Subject: RE: Steel in SeaQuest
From: Kurt J Krempetz <krempetz@fnal.gov>
Date: 3/5/12 11:20 AM
To: Leo Bellantoni <bellanto@fnal.gov>
CC: David C Christian <dcc@fnal.gov>, Paul E Reimer <reimer@anl.gov>

There is a wall of iron in SeaQuest, called "The Iron Wall" between stations 3& 4. We would like to get this experiment an ORD PDQ. Will The Iron Wall need a seismic stability study? The experimenters have some rough calculations -

Physical Properties for Station 3 Iron Blocks

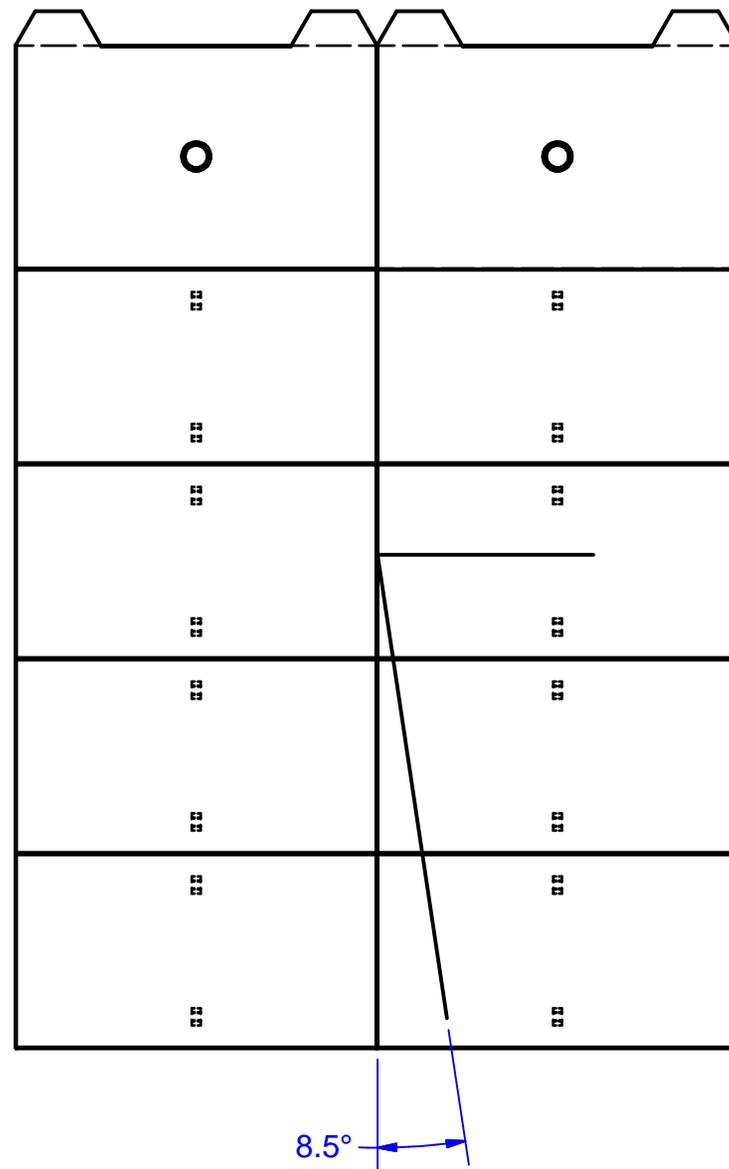
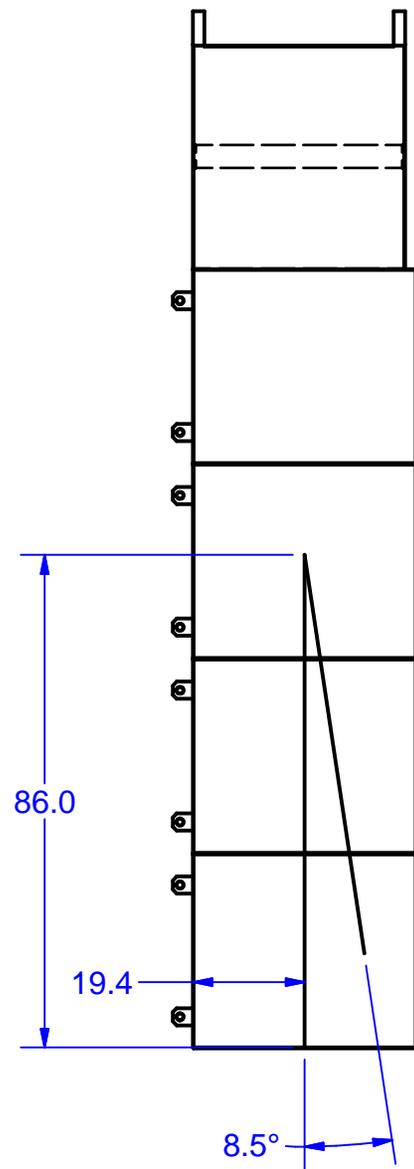
I've reviewed the information Paul has sent. Typically we consider a structures which can withstand .1g force in any direction as an acceptable criteria. Paul used .15g's in his calculations and showed the wall was stable. This .1g number is derived from an older version of ASCE/SEI 7-10 Minimum Design Loads for Buildings and other Structures.

I agree with your analysis Kevin. It should be stable under such a load but I have two comments:

I think your method implies a solid wall instead of the individual iron blocks. However, the individual blocks are of such a geometry that individual seismic loads will produce the same line of force. This line is within the blocks too so there is no chance of tipping over. They would slide before they tipped which brings me to my second comment.

These blocks are not secured to the floor or to each other so someone might wonder if the seismic load could result in slipping between blocks or between the blocks and the concrete floor. The assumed load is 15% of the weight so if the coefficient of friction is less than 0.15 (either between iron/iron or iron/concrete) then slippage may occur. I did some casual searching and found an iron/iron coefficient 1.0 so thats not a problem. I couldn't find anything for iron/cement but i bet it's high enough too. As an example, nylon/nylon has a coefficient of about 0.15, which seems quite slippery by comparison. I don't think we need to change Kevin's analysis unless this comes up in your discussions and they ask for more details.

LINE OF FORCE IS WITHING THE IRON WALL
IRON WALL IS STABLE UNDER THESE SEISMIC FORCES
